**SCOPE OF WORK FOR
ADDITIONAL RI SAMPLING**

MALTA ROCKET FUEL AREA SITE

TO: Daniel Steenberge, RHWRE, Region 5 - Ray Brook
FROM: Marsden Chen, Bureau of Eastern Remedial Action, DHWR
SUBJECT: Malta Rocket Fuel Area Site ID No. 546022

Re: Malta Rocket Fuel Area Site - Scope of Work for Additional RI Sampling

PROPOSED PHASE II SURFACE WATER AND SEDIMENT SAMPLE LOCATION MAP

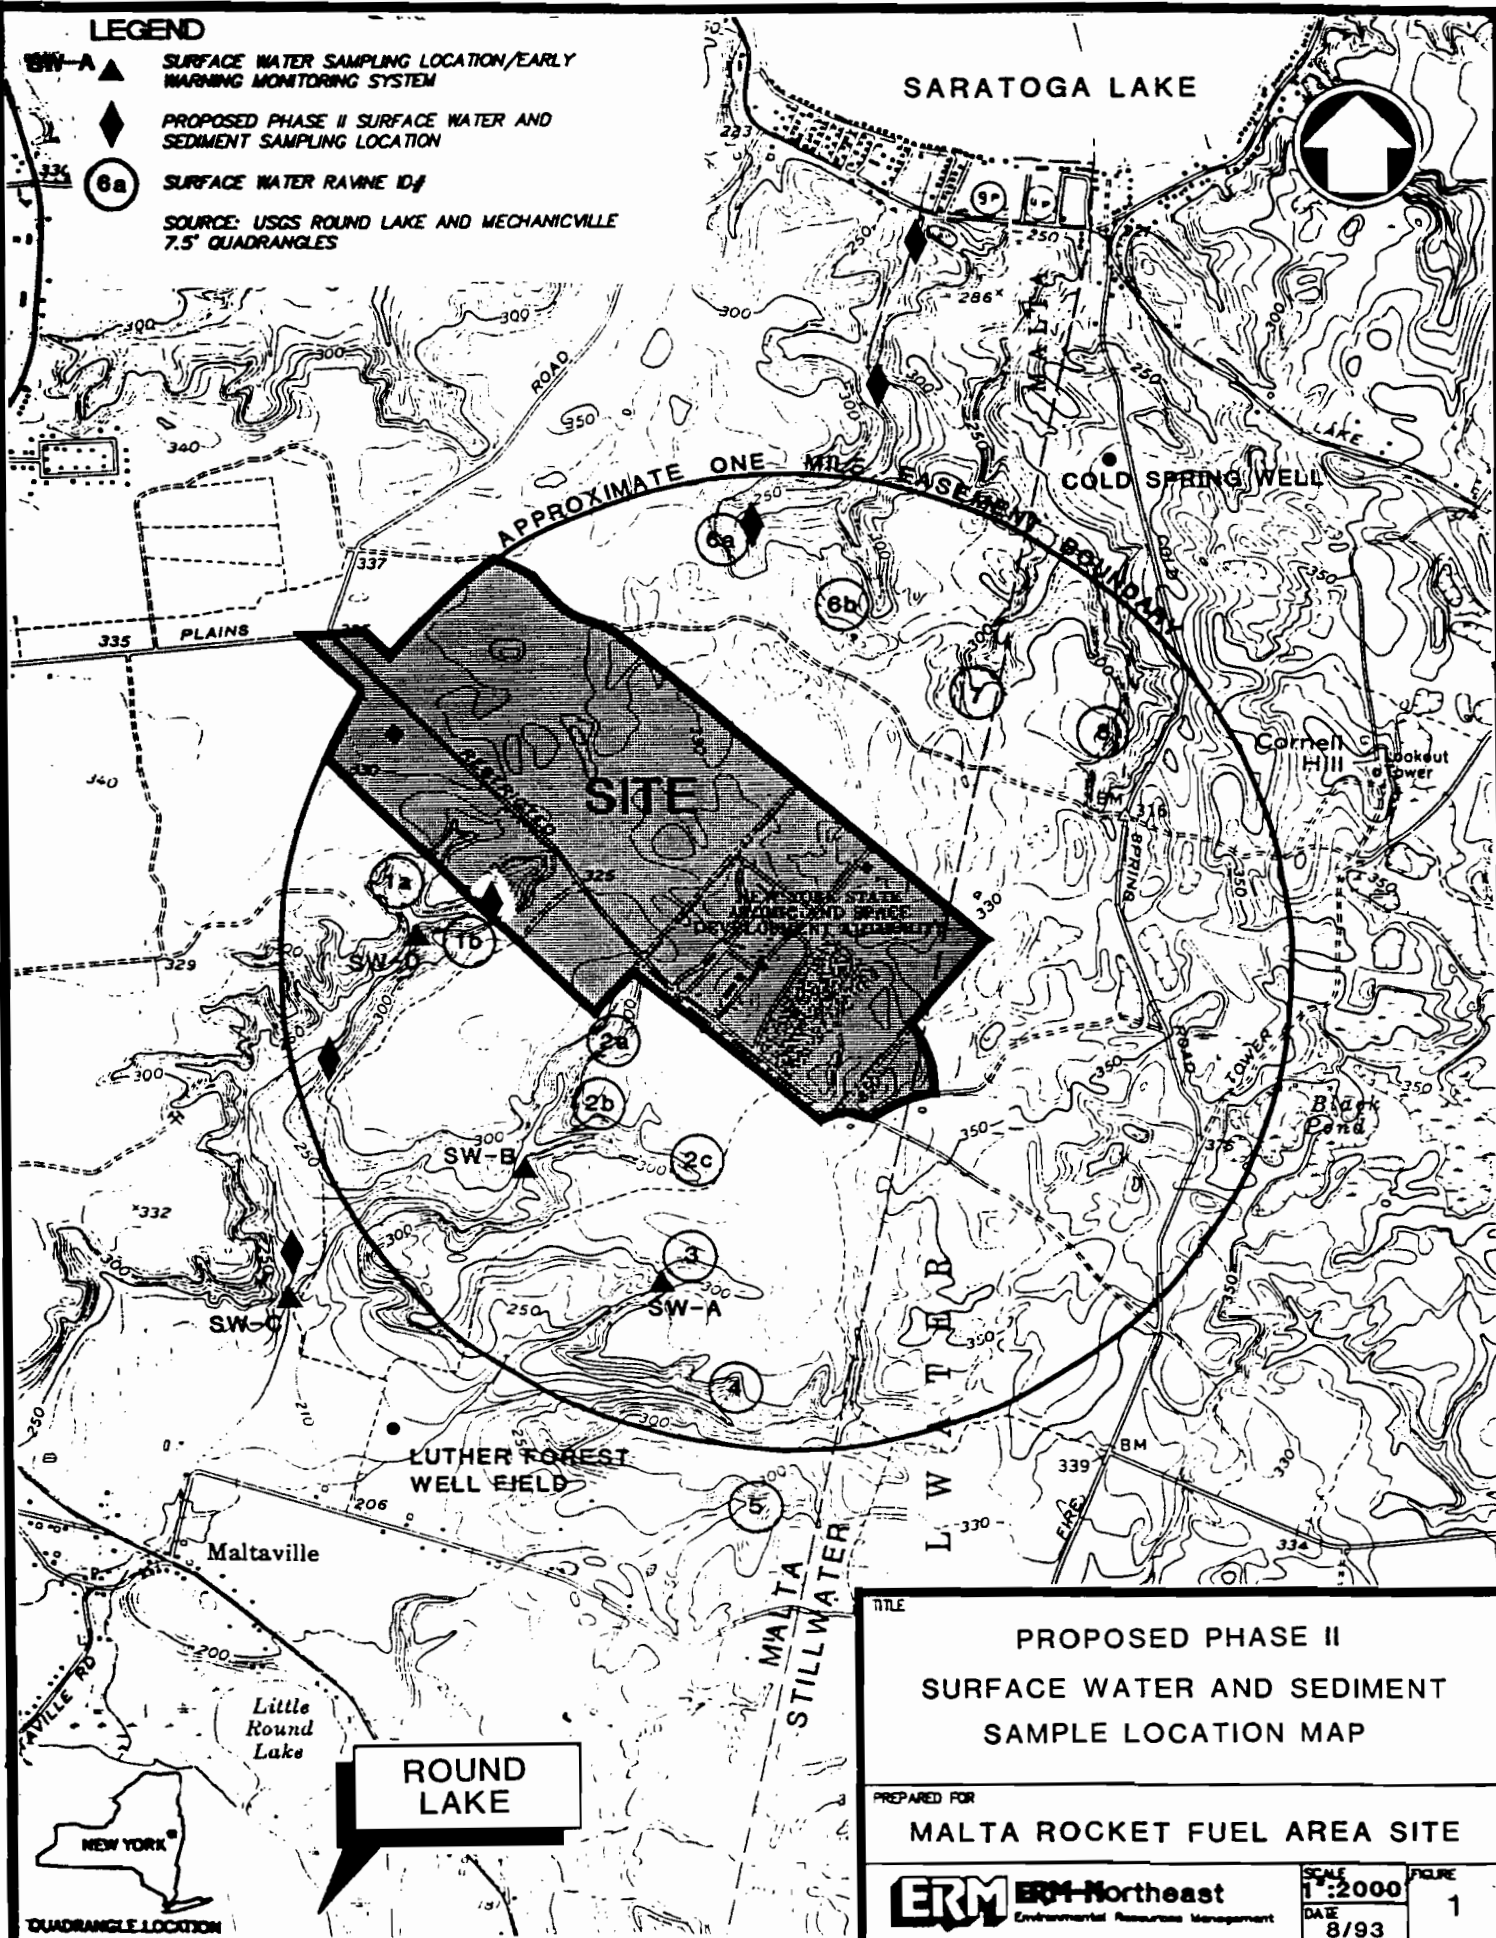
The USEPA 8 July 1993 comments #102 and #103 address the collection of background surface water sampling to provide inorganic analytical data for comparison with the Draft RI surface water analytical results and comments #152 and #155 address additional surface water sampling in Ravine 1b. Further comments concerning the sample collection procedures and schedule for the proposed additional surface water sample collection were provided in the USEPA letter dated 3 September 1993. In addition, the Pathway Analysis Report (Section 3.0, A.) indicates surface water samples should be collected at multiple points in Ravine 1b and in the other ravines (2a, 2b, and 2c) southwest of the MRFA Site. The Respondents are in agreement that background surface water analytical data will be useful for

comparison with site surface water data and that the sampling of multiple points in certain ravines is appropriate. Additional sampling of Ravines 2a, 2b, and 2c, however, is not necessary as these ravines are already sampled quarterly as part of the Early Warning Monitoring System (EWMS). Therefore, the Respondents propose additional surface water sampling in Ravines 1b and 6a only.

Topographically and hydrologically, there are no surface water bodies upstream or upgradient of the MRFA Site or the Draft RI surface water sampling locations. As can be seen on the topographic map (Figure 1), the MRFA Site is located in close proximity to the drainage divide between Saratoga Lake and Round Lake and the various ravine seeps that surround the site (1a, 1b, 2a, 2b, 2c, 3, 4, 5, 6a, 6b, 7, and 8). Even though all these ravines are topographically and hydrologically located downgradient of the MRFA Site, sampling a ravine north of the site will most likely provide the most accurate assessment of background conditions for surface water. The reason for this is twofold: (1) most, if not all, groundwater affected by the MRFA Site flows to the southwest and (2) the ravines north of the site are not believed to be affected by site activities. Therefore, the Respondents propose to collect three surface water samples from Ravine 6a for inorganic analyses (TAL plus boron) to provide background analytical data to compare to MRFA Site surface water analytical data. The locations of these proposed surface water sampling points are shown on Figure 1.

The Respondents are also proposing the sampling of Ravine 1b at three different locations shown on Figure 1 for inorganic analyses (TAL plus boron). This sampling of Ravine 1b will assess the potential of site-affected ground water discharging along multiple points along the ravine, which will provide useful data for the risk assessment evaluation for surface water exposure.

useful in providing inorganic analytical data for comparison to site sediment analytical data. Thus, the collection of three background sediment samples from Ravine 6a is proposed at the same locations of the proposed background surface water sampling points provided on Figure 1. Three Ravine 1b sediment samples are also proposed for collection at the same locations as the proposed Ravine 1b surface water sampling locations (see Figure 1). This sediment sampling will help assess the extent of inorganic constituents in sediment detected during the previous investigation. TOC will not be analyzed for in the ravine sediment samples since only inorganic constituents are being investigated. Sediment samples from Ravine 6a and 1b will be collected in accordance with the sampling procedure outlined in Section 5.16.1 of the USEPA approved POP as conducted during the initial RI investigation.

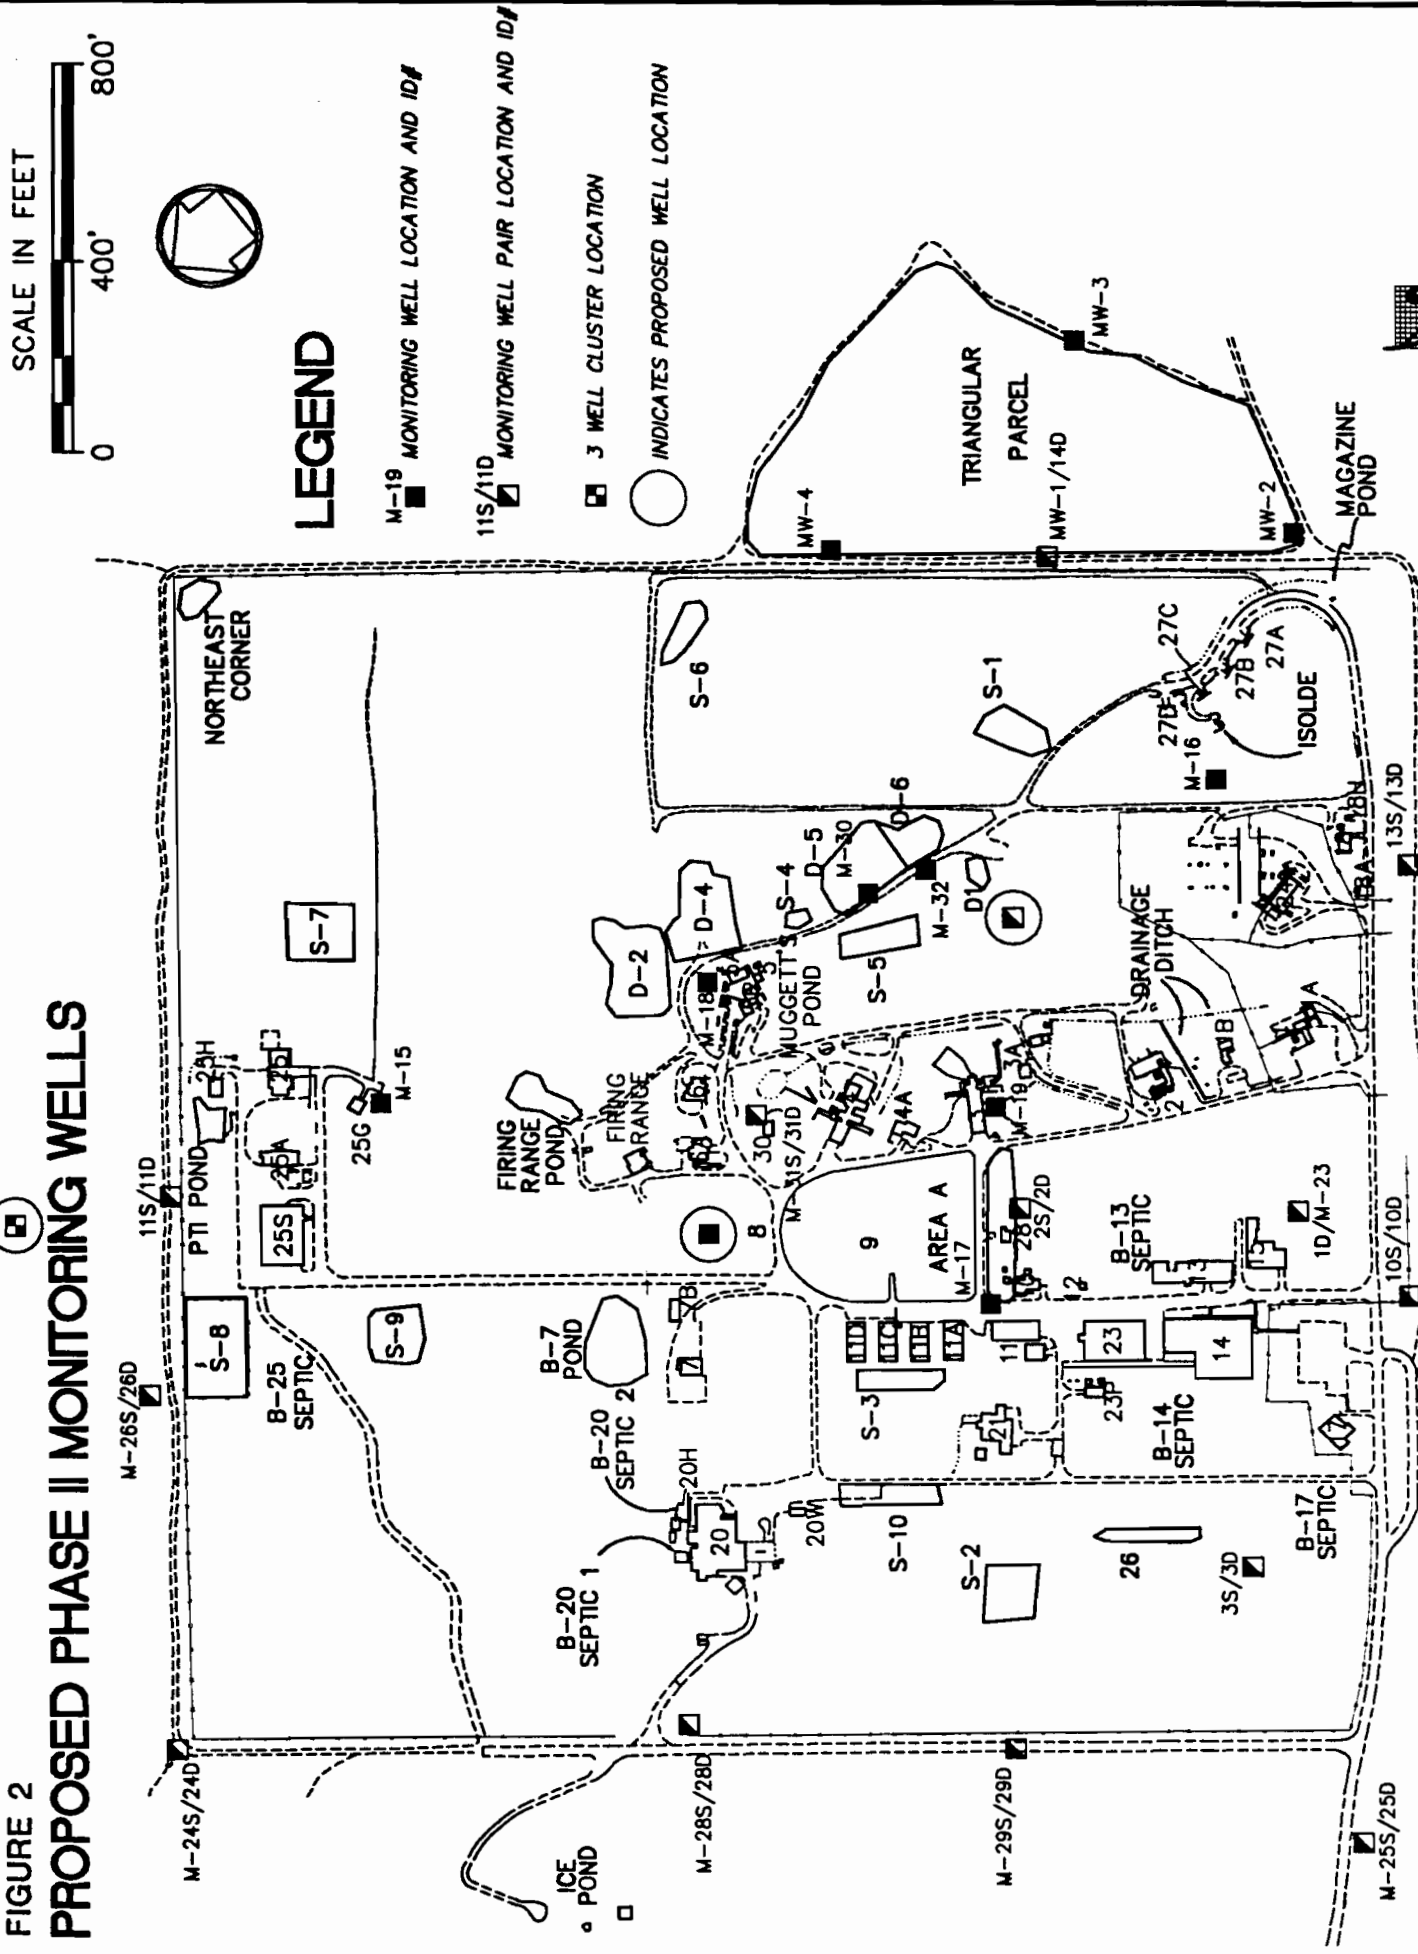
The USEPA comments (#117, 130, 131, 133, 165, 173, 179, 183, 193, 213, 223, 228, 231, 236, 240, 263, 270, and 275) requested additional groundwater investigations at several areas across the site (Areas S-2, S-3, S-5, S-10, D-5, Triangular Parcel, GE/Exxon, and Buildings 1, 2, 3, 5, 20, 21, 23, 24, and 25). Most of the additional investigation requested is focused within the footprint of the ground water plume identified in the Draft RI Report. Further comments concerning monitoring well construction, development, and sampling procedures as well as laboratory analyses for the proposed additional ground water investigation were provided in the USEPA letter dated 3 September 1993.

The areal extent of ground water affected by site activities has been investigated; however, six additional wells have been proposed by the Respondents' to refine the delineation of the extent of the plume. The Respondents propose installing these six wells at three locations (see Figure 2). Five of these wells (a well pair downgradient of Area D-1, a single shallow well downgradient of Building 6, and a well pair northeast of Building 25) were proposed in the Draft RI Report. The sixth well is proposed in lieu of a ground water model (Comment #89). This would be a deep well (approximately 300 feet deep) screened in the deep aquifer tapped by the Cold Springs public water supply well. This deep well will be northeast of Building 25 at the same location of the well pair proposed in the Draft RI Report, which will become a three well cluster. This well cluster can then be added to the EWMS quarterly sampling.
